SUBJECT: **San Onofre Nuclear Generating Station, Units 2 and 3**
Docket Nos. 50-361 and 50-362
Additional Information Regarding
Proposed Change Number (PCN) 561
Degraded Voltage Setpoints

PCN 561 NRC Questions and SCE Responses

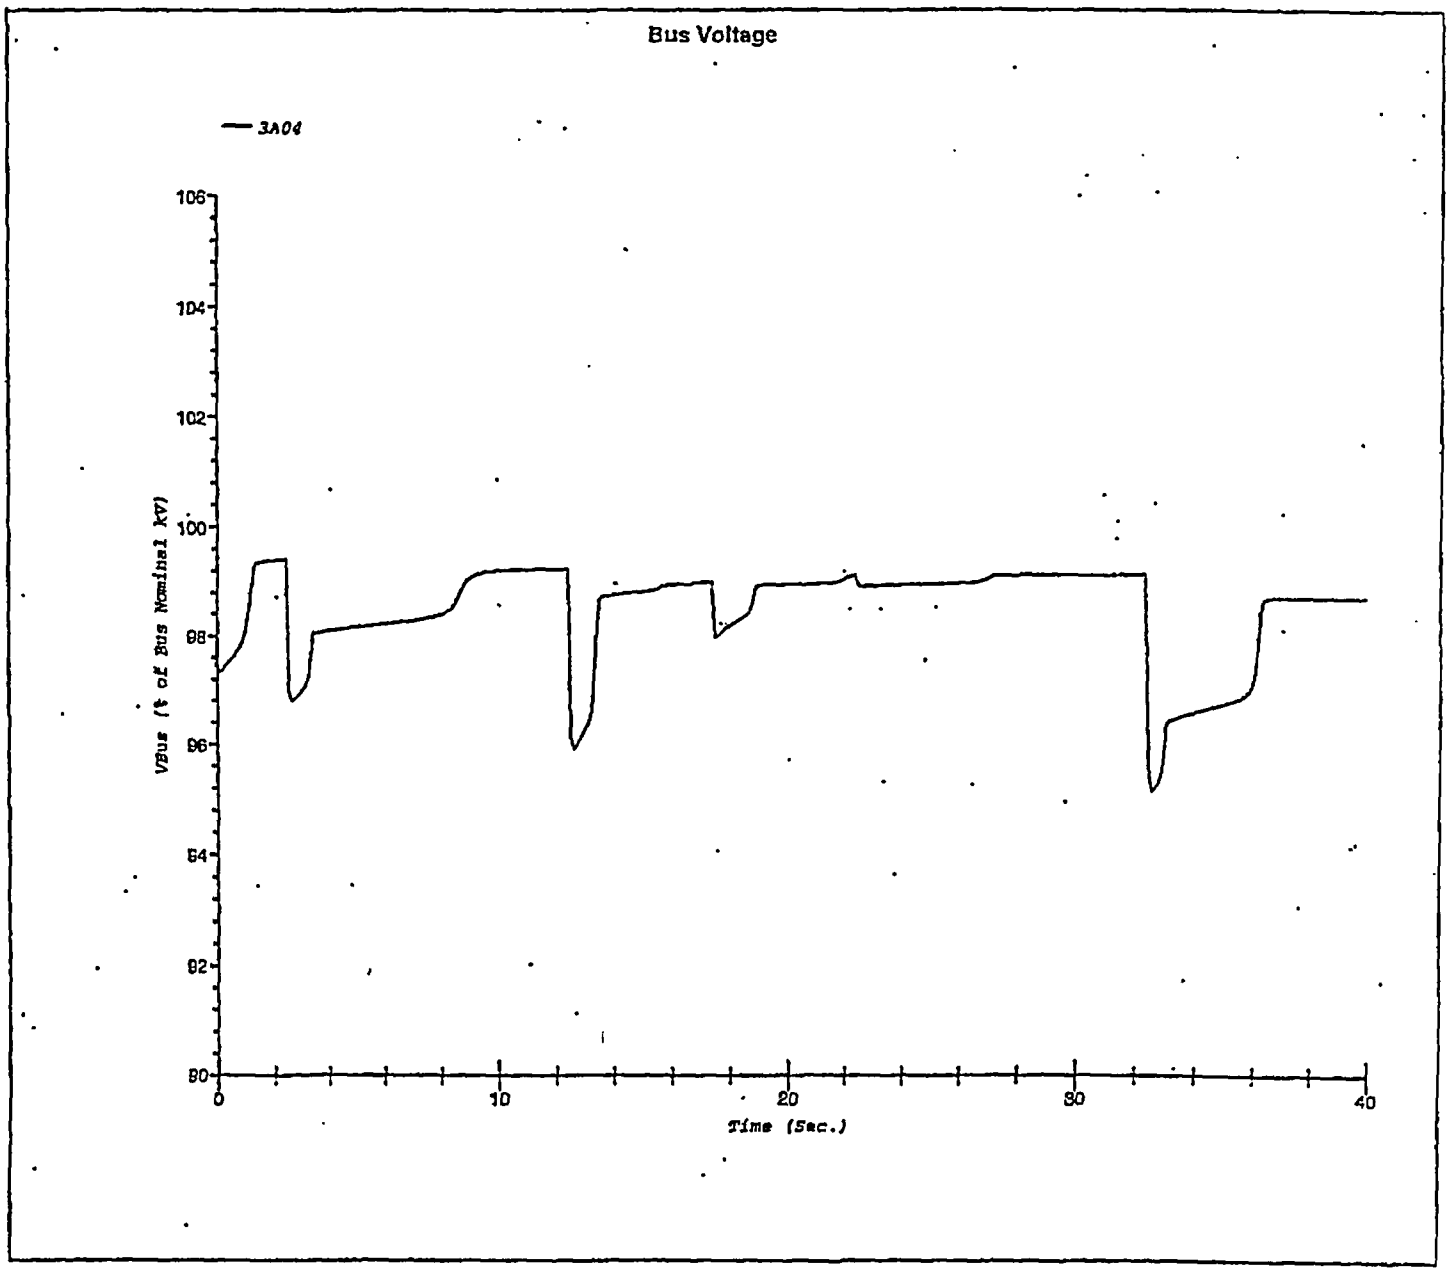
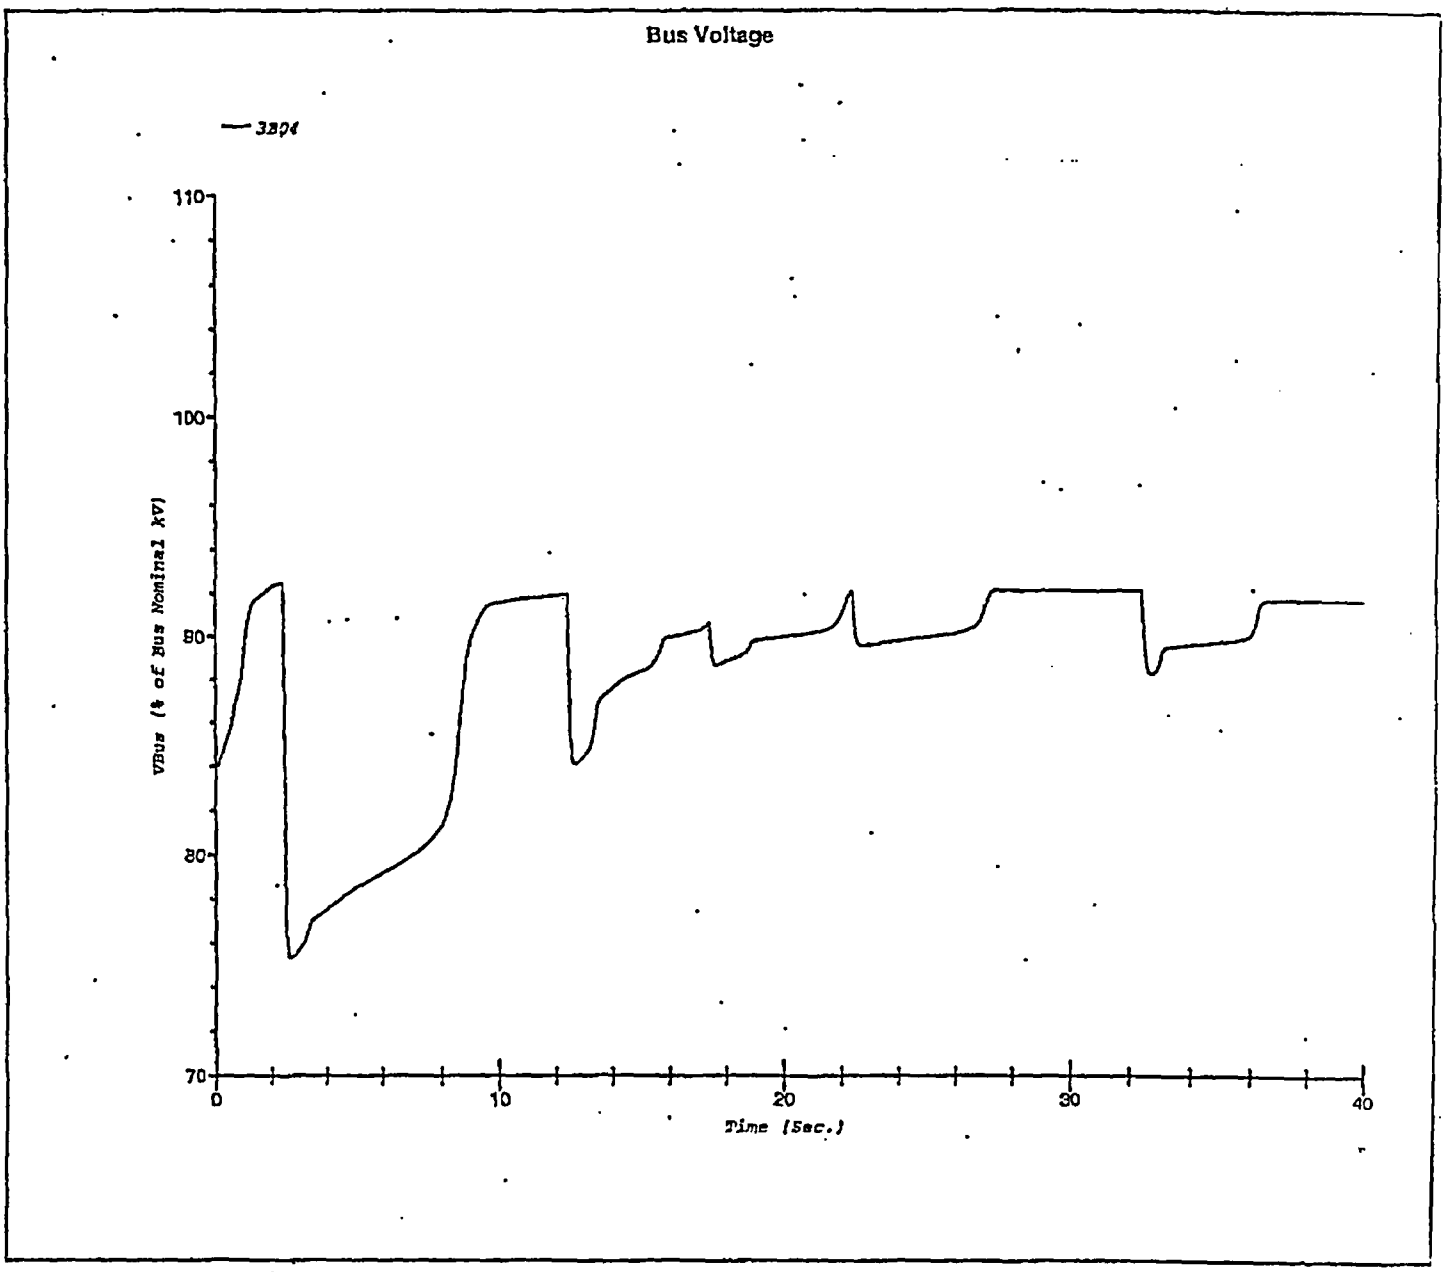
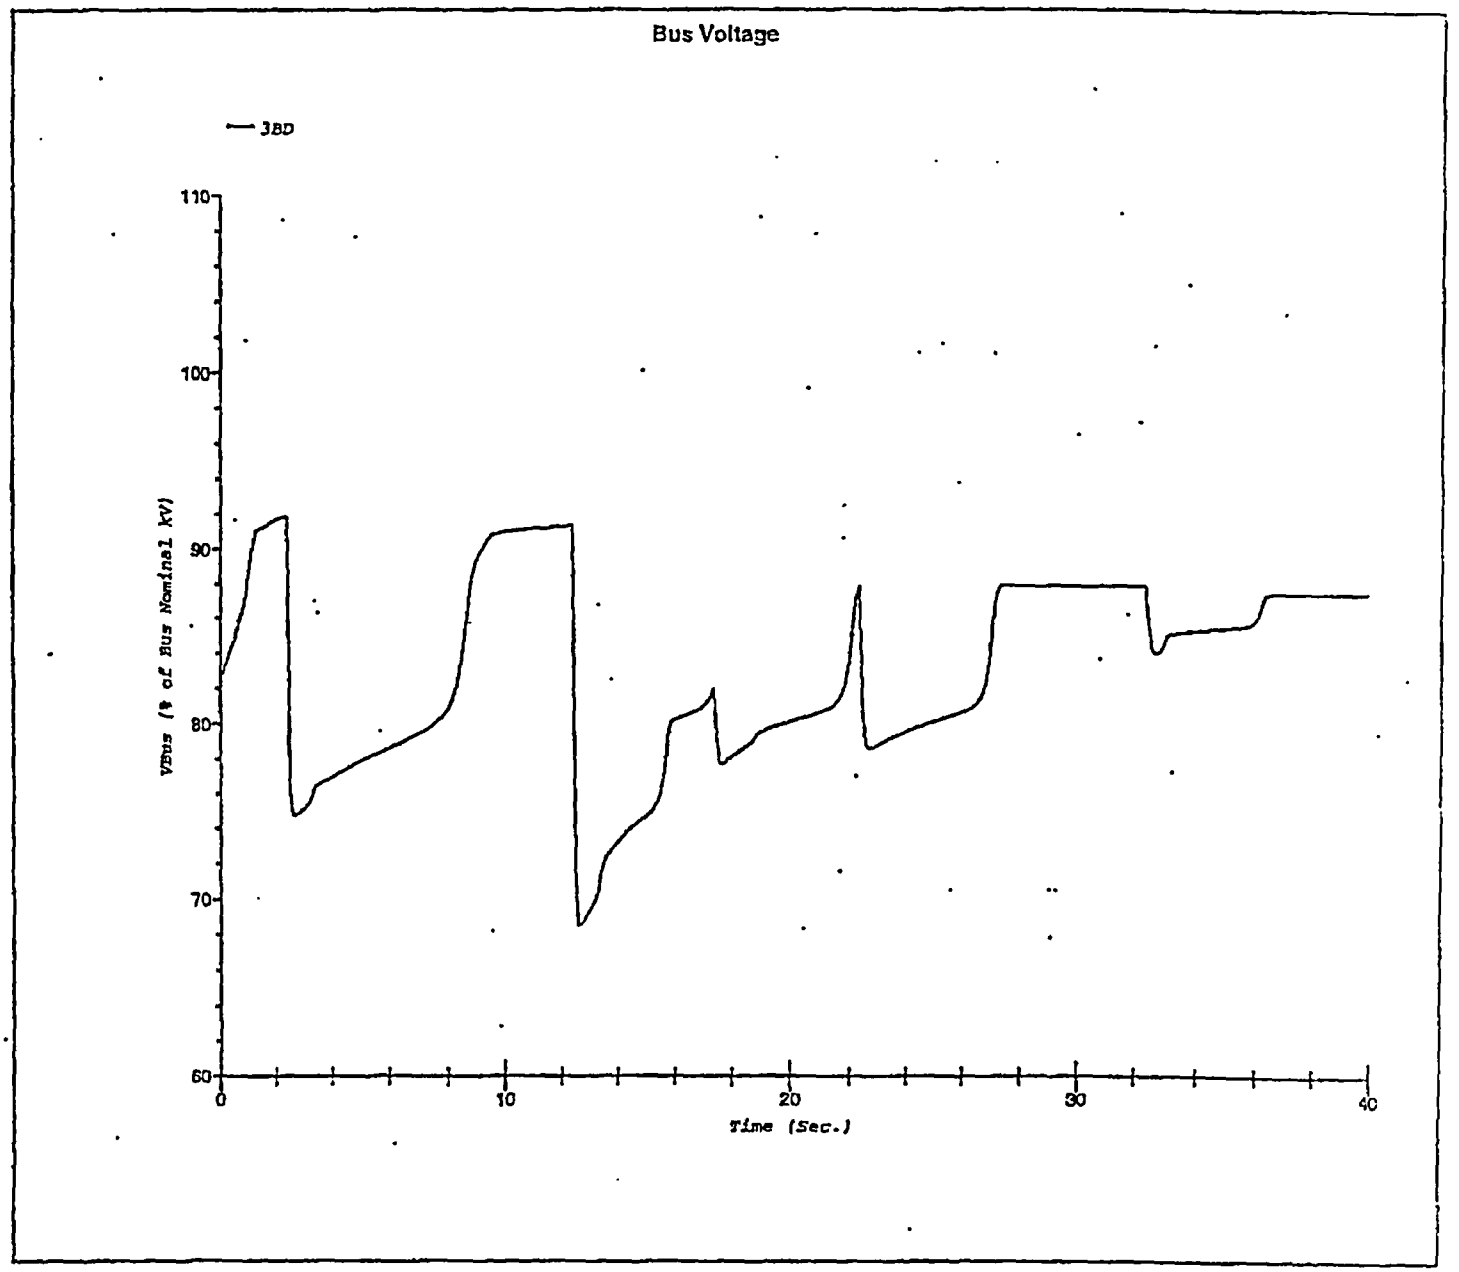
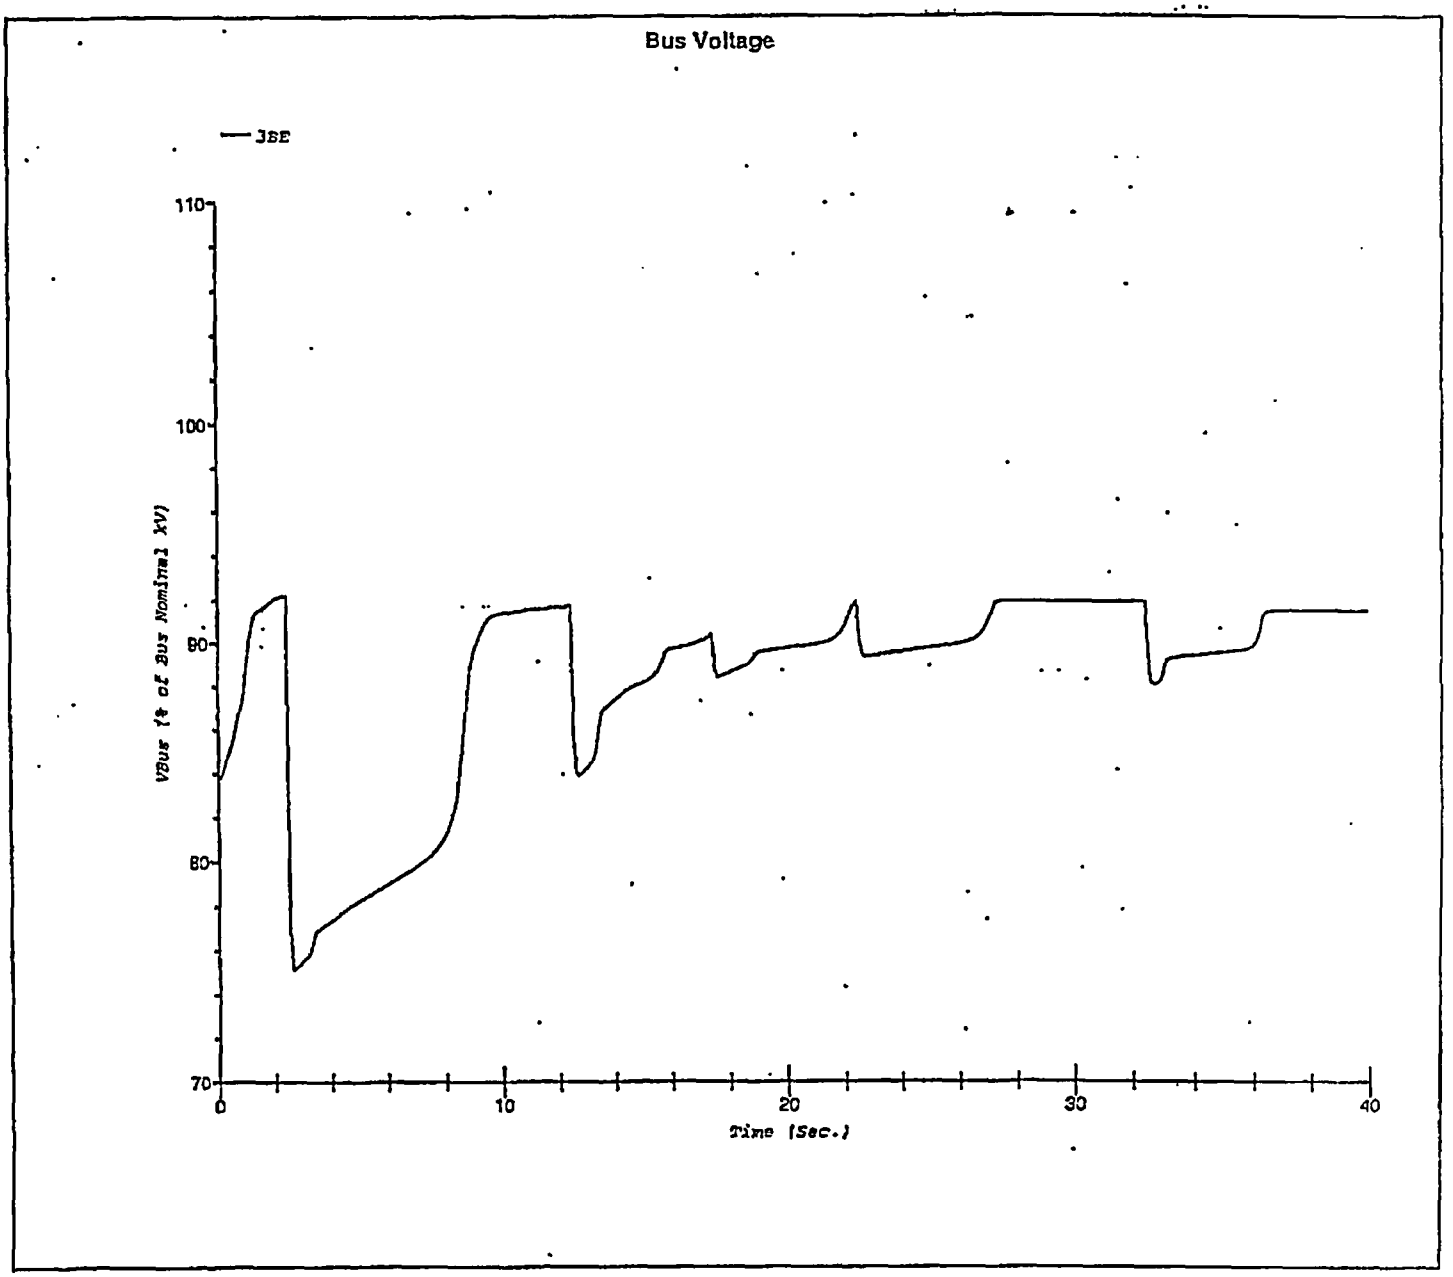
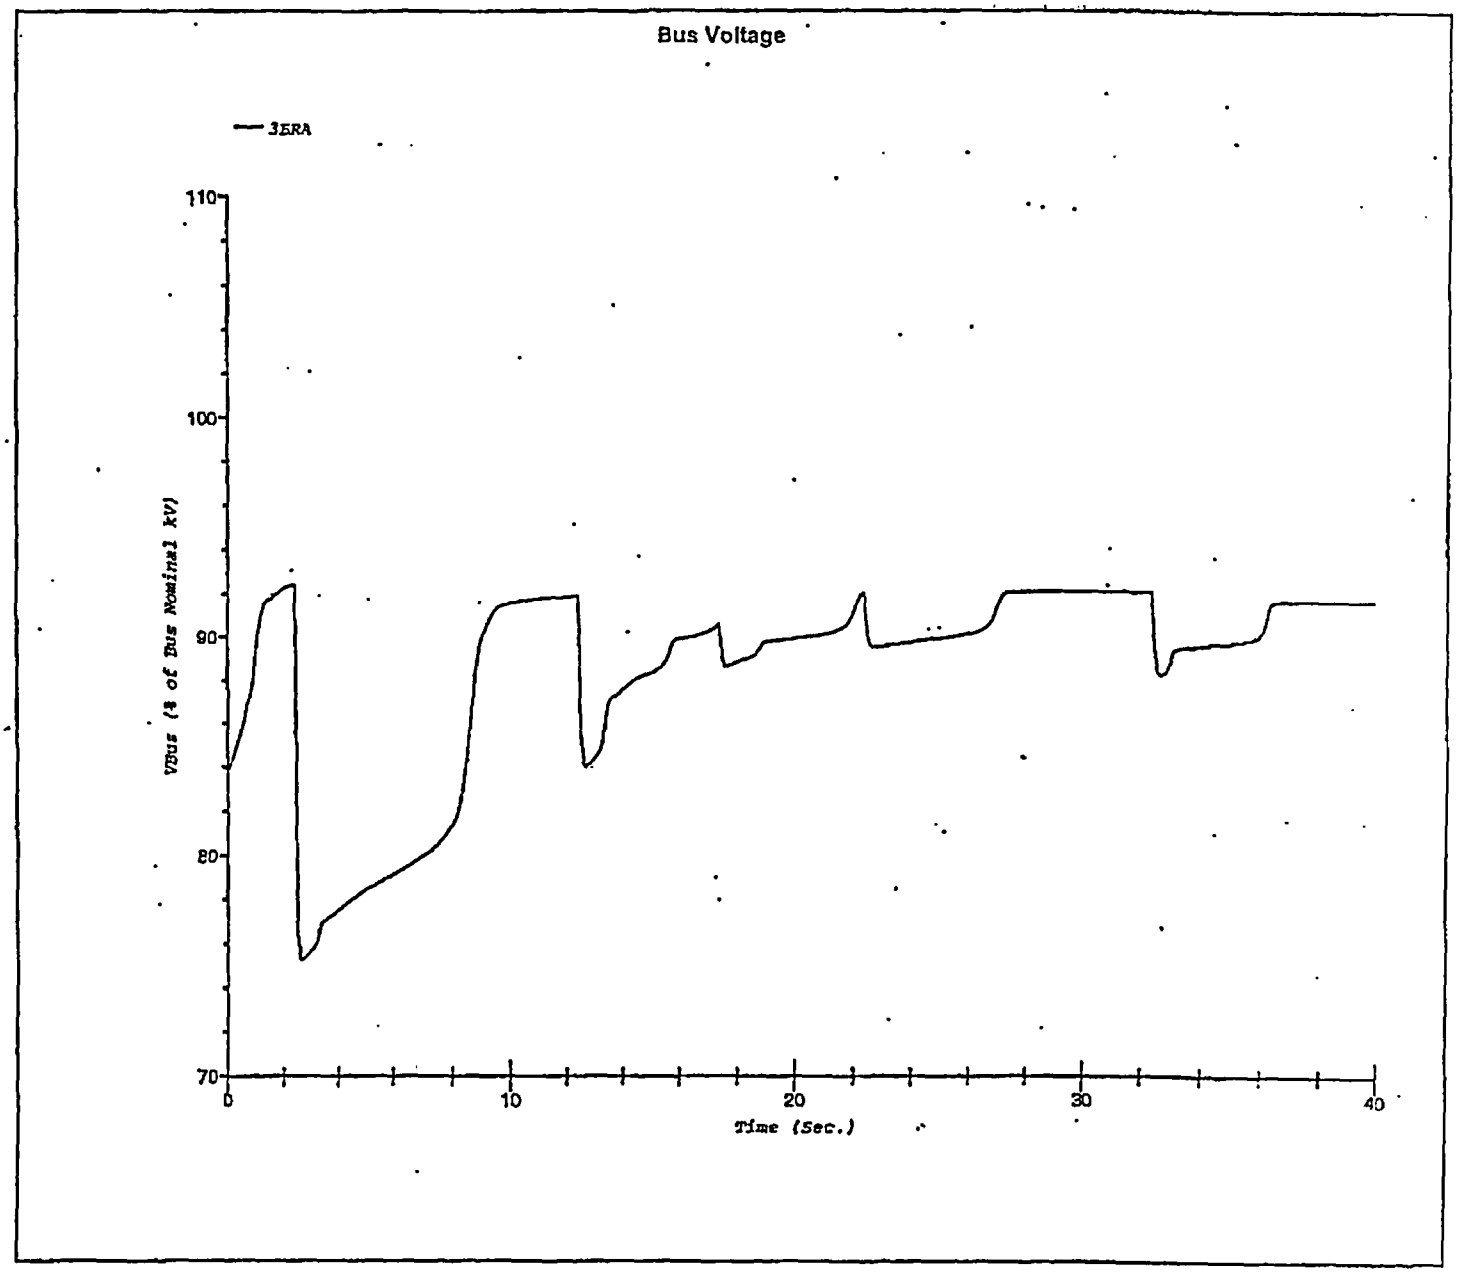
Send a copy of the sequencing overlap calculation graph that demonstrates the imprecise (but within allowable value) sequence timer operation is acceptable.

See Attachment 4, "Calculation E4C-082, PCCN N-19, 'System Dynamic Voltages During DBA.'"
